DESCRIPTIVE REPORT

Registry No. H11623

General Locality Mobile Bay

Sublocality Fowl River Point to Pass aux Herons

Figure 14. Obstruction 1, side scan contact 109-165001-S, near charted “tank”

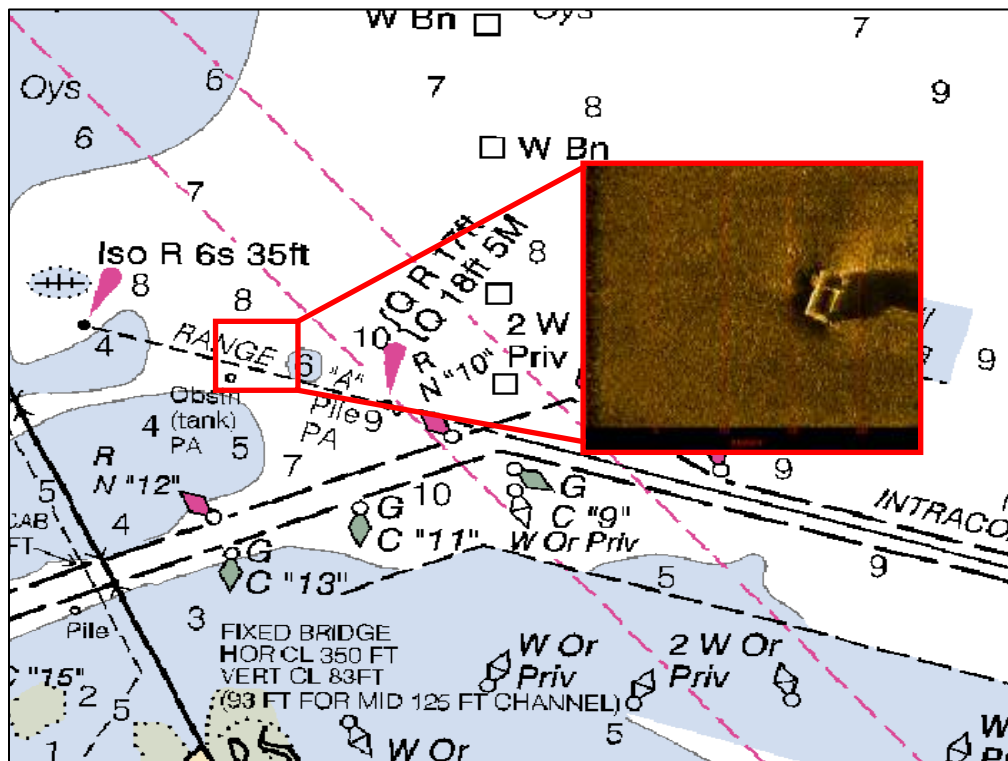
Obstruction 1, Figure 14, is an obstruction located approximately 100 m to the NE of the disproved charted Obstrn (tank). The hydrographer recommends charting the new obstruction at 30-17-43.12N, 088-07-29.25W. **Concur. Chart 7-ft (2.353m) Obstruction at surveyed location. Recommend to update AWOIS #3514 with H11623 results.**

Figure 15. Obstruction 2 near charted 5-ft shoal

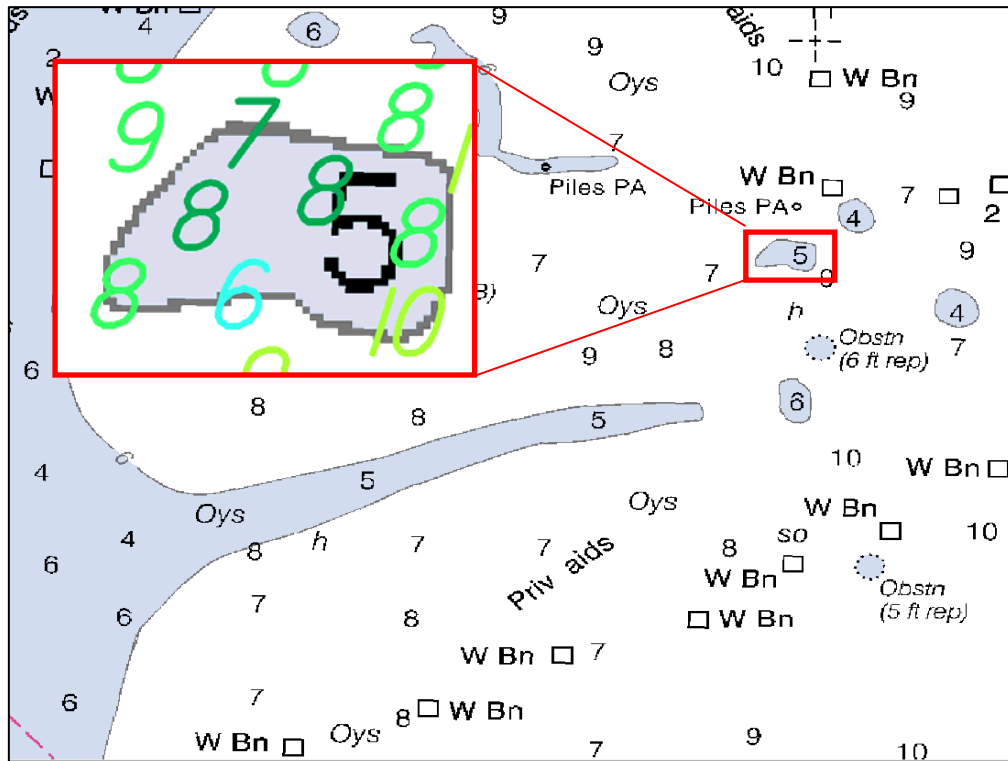
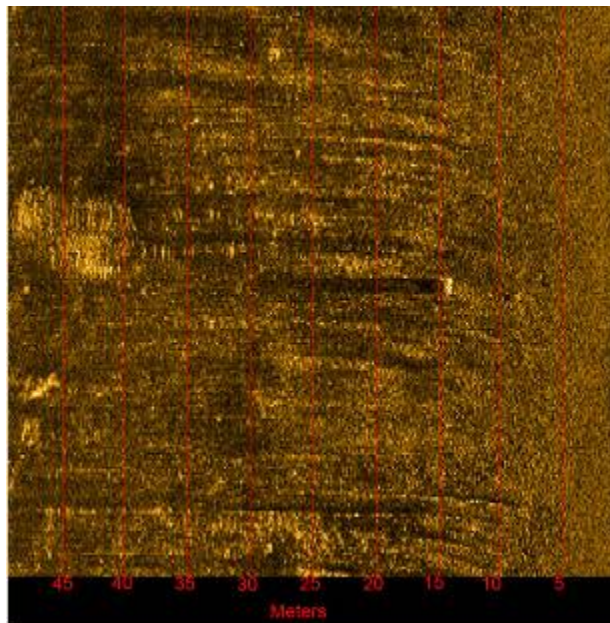
Obstruction 2, Figures 15 and 16, is an obstruction located in the vicinity of a charted five-foot shoal. The multibeam least depth on the square obstruction is 6 feet (2.03 m). The hydrographer recommends charting depths based on current hydrography and charting a new obstruction at 30-19-16.09N, 088-06-11.60W. **Concur. Chart 6-ft Obstruction with a least depth of 6.66-ft (2.03m) at the surveyed location.**

Figure 3. Obstruction 3 near charted 9-ft sounding

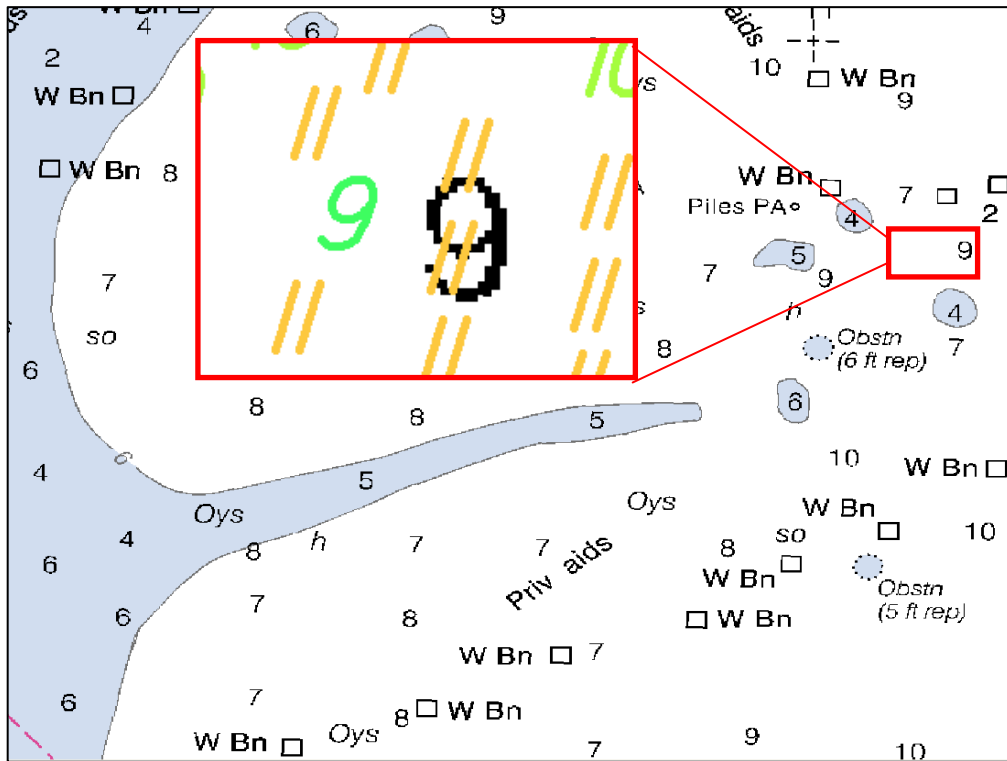
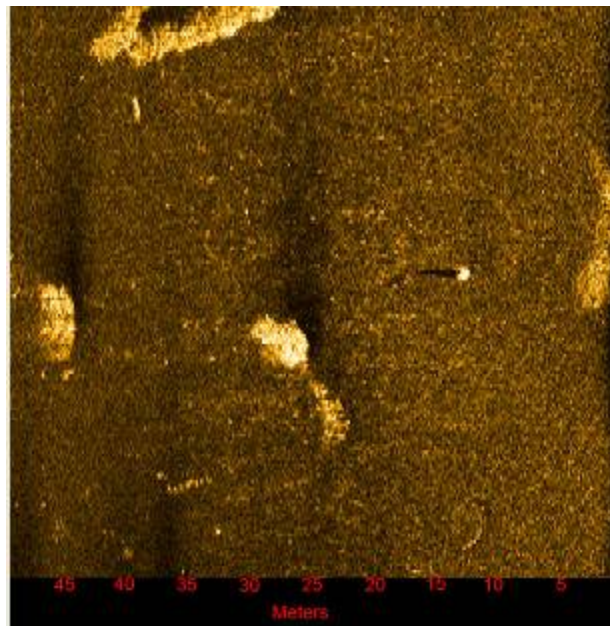
Obstruction 3, Figures 17 and 18, is a new obstruction was located by the present survey at 30-19-18.49N, 088-05-52.03W. The hydrographer believes that the charted 9-ft sounding and the new obstruction may be the same feature and recommends charting the area based on current hydrography. **Concur with clarification. The second 100% side scan was not acquired as per SOW thus limiting the SS to MB comparison. Feature observed in one side scan line and four MBES development lines; the submitted bathy data was not supported by the side scan imagery. Recommend to chart a 10-ft (2.98m = 9.77-ft) Obstruction at the surveyed location in Latitude 30°19'18.855"N, Longitude 088°05'52.275"W.**

Figure 19. Obstruction 4 near charted pipeline side scan contact 109-164210

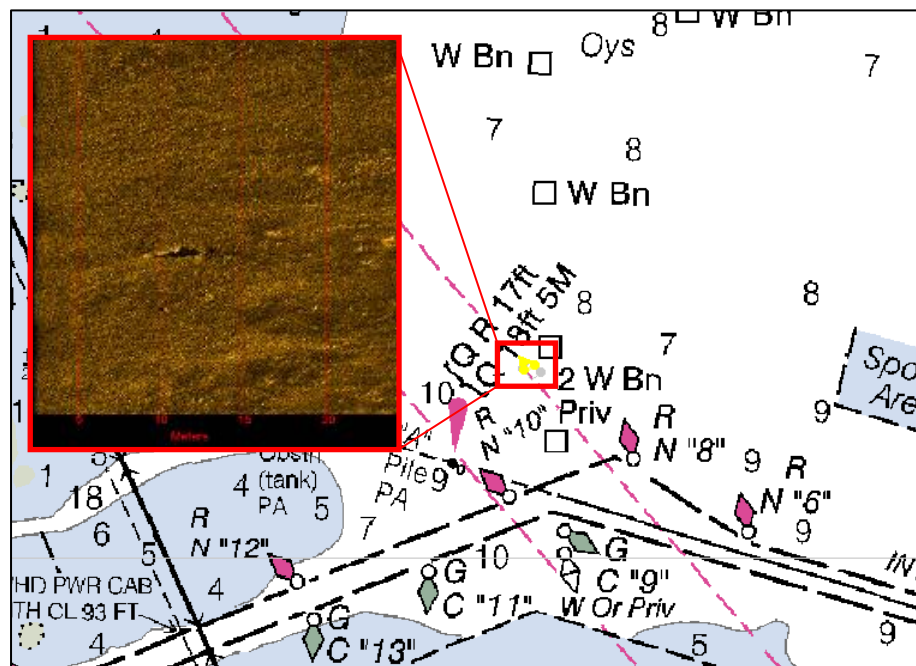
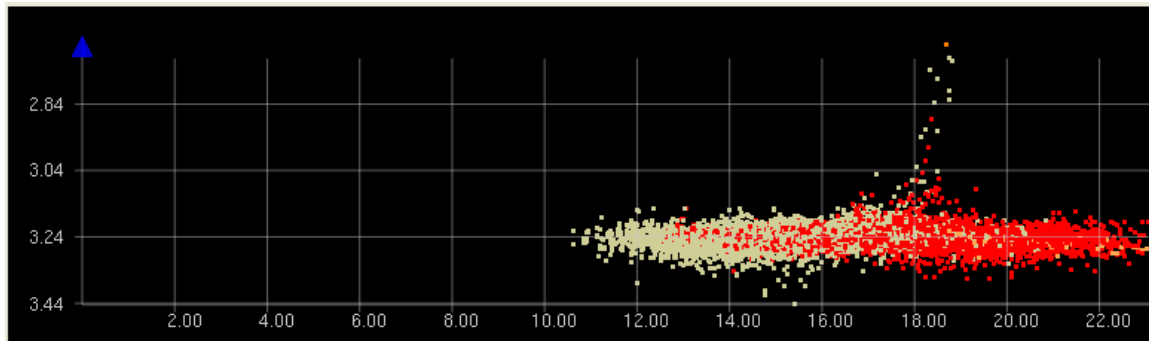
Obstruction 4, Figures 19 and 20, is a new obstruction was located by the present survey. It is possible that this feature is a submerged buoy. The obstruction is located near the south west extents of H11623, in the vicinity of a charted cable area. The hydrographer recommends charting a new obstruction at 30-17-47.21N, 088-07-08.59W. **Concur with clarification. Recommend to chart a 8-ft Obstruction (least depth of 2.651m (8.69-ft)) at the surveyed location.**

Figure 21. Obstruction 5

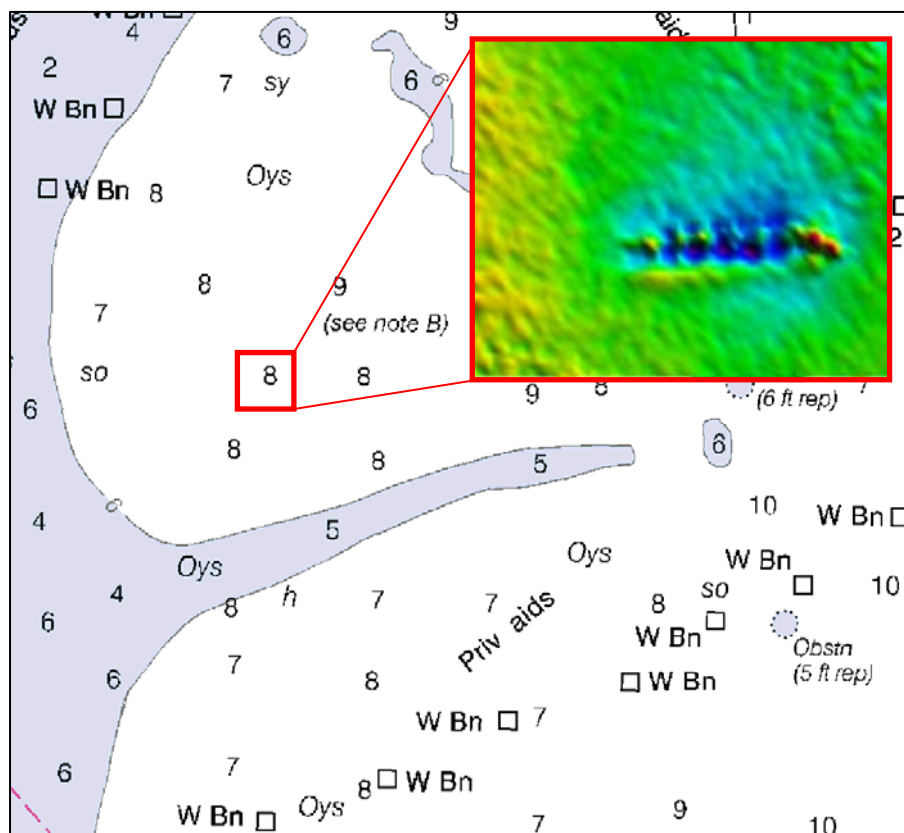
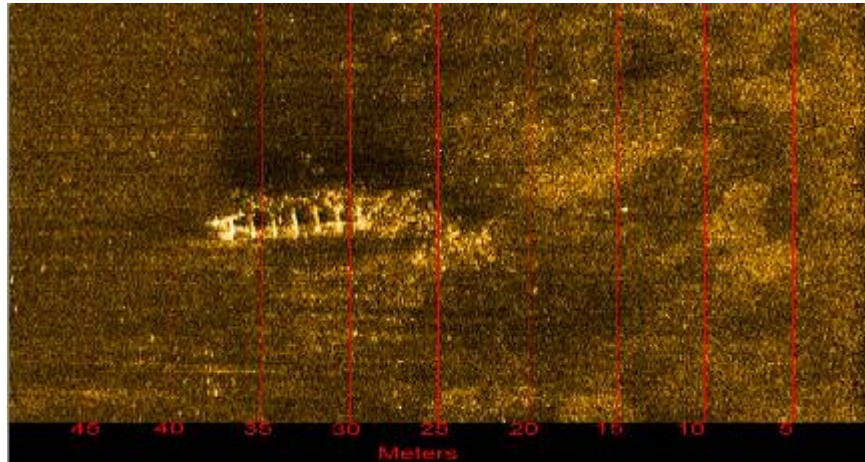
Obstruction 5, Figures 21 and 22, is a new obstruction located by this survey and appears to be a wreck with ribs visible in the side scan imagery. The feature stands approximately 1-ft proud of the surrounding seabed. Current survey depths in the vicinity are 8 ft and 9 ft. The hydrographer recommends charting a new wreck at 30-19-06.32N, 088-07-07.76W. **Concur. Recommend to chart a Wreck with least depth of 7-ft (2.309m (7.575-ft)) at the surveyed location.**

Figure 23. Obstruction 6, contact 70-153226-S

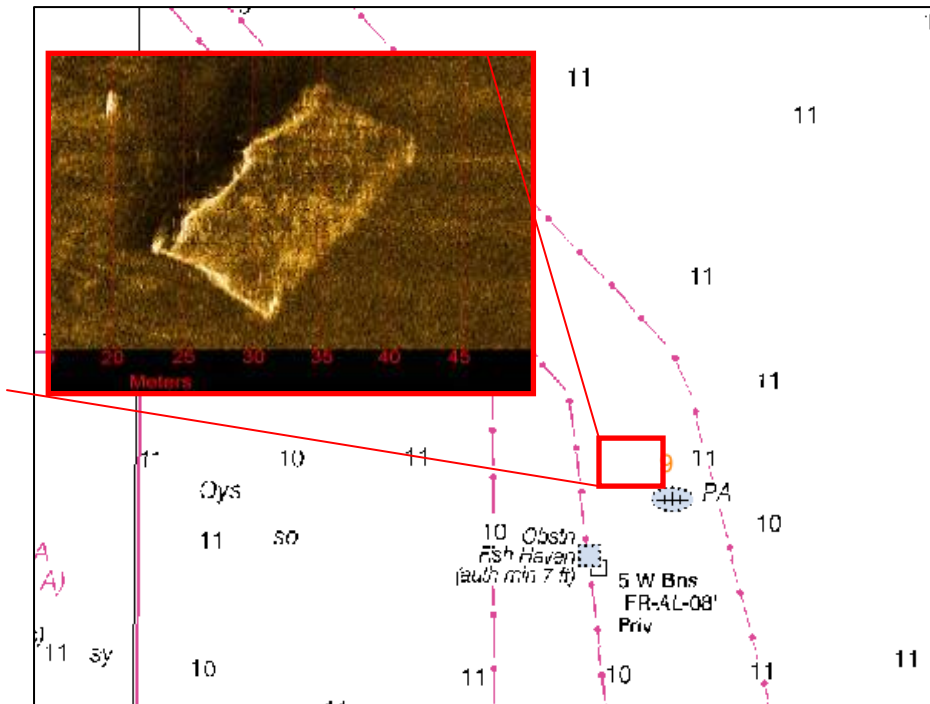
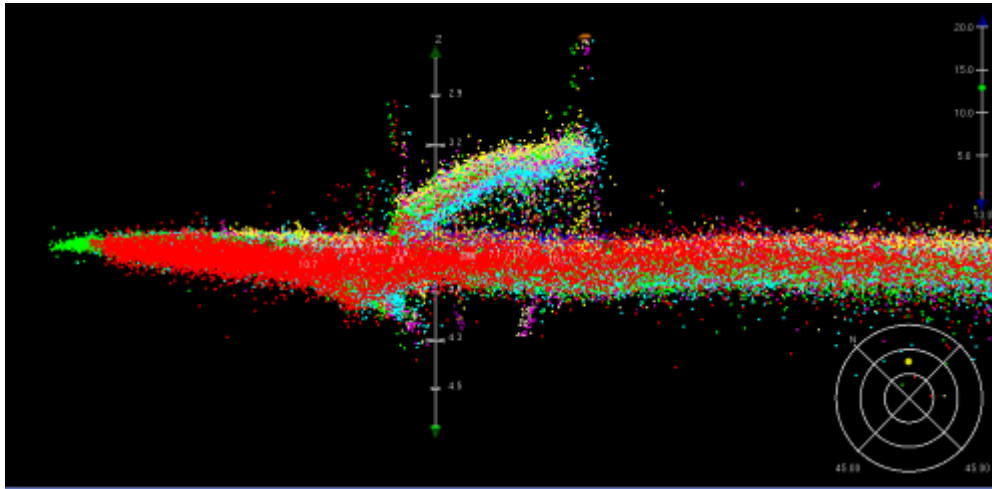
Obstruction 6, Figures 23 and 24, is a new obstruction was located approximately 100 m north of a charted PA wreck (Item # CF 41). The least depth of the obstruction is 9 ft (2.9 m) and surrounding depths are 12 ft (3.6 m). The hydrographer recommends removing the charted PA wreck and charting a new obstruction at 30-20-48.41N, 088-03-42.69W. **Concur with clarification. Recommend to chart a submerged 9-ft wreck (barge) with a least depth of 2.944m (9.658-ft) at the surveyed location in Latitude 30°20'48.13"N, Longitude 088°03'42.79"W. Reference page 17 of this report, AWOIS #3529.**

Figure 265. Chartlet of transient obstruction on H11623

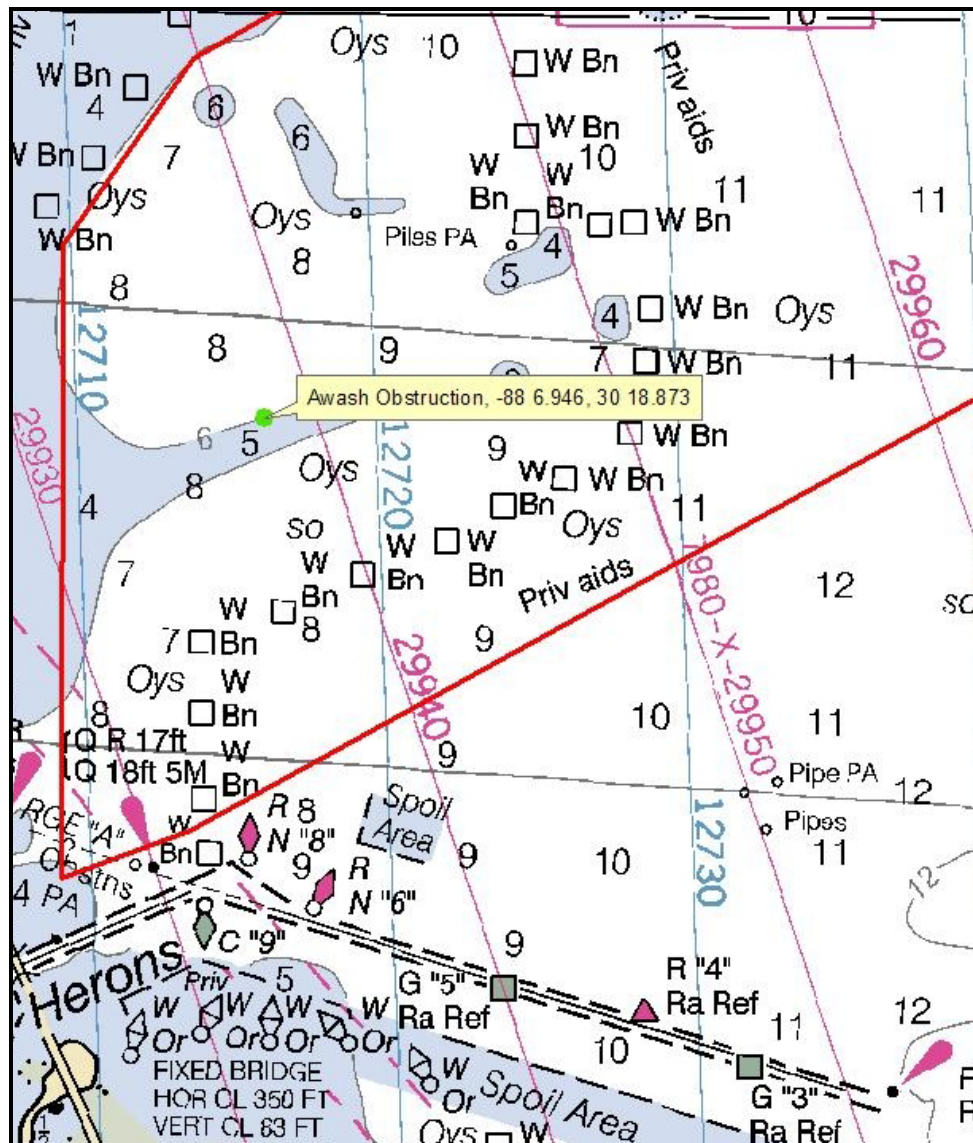
Obstruction 7, Figures 25 and 26, is a transient feature located in H11623. The obstruction appears to be an awash oyster bed stake with a weighted base that moves randomly during high tides and heavy weather. The obstruction was first located at 30-18-49.19N, 88-06-58.27W. During further investigation it was found to have migrated approximately 107 m to the north. The stake can be pulled up, but is too cumbersome to be pulled free of the bottom by hand. This obstruction was reported to the Eastern Gulf of Mexico Region Navigation Manager, Tim Osborn, on November 29, 2007⁵. A Broadcast Notice to Mariners was issued for this obstruction and is also posted in the LNM 49/07. It is recommended that this feature not be charted as it is a transient feature. **Concur. No charting action required.**
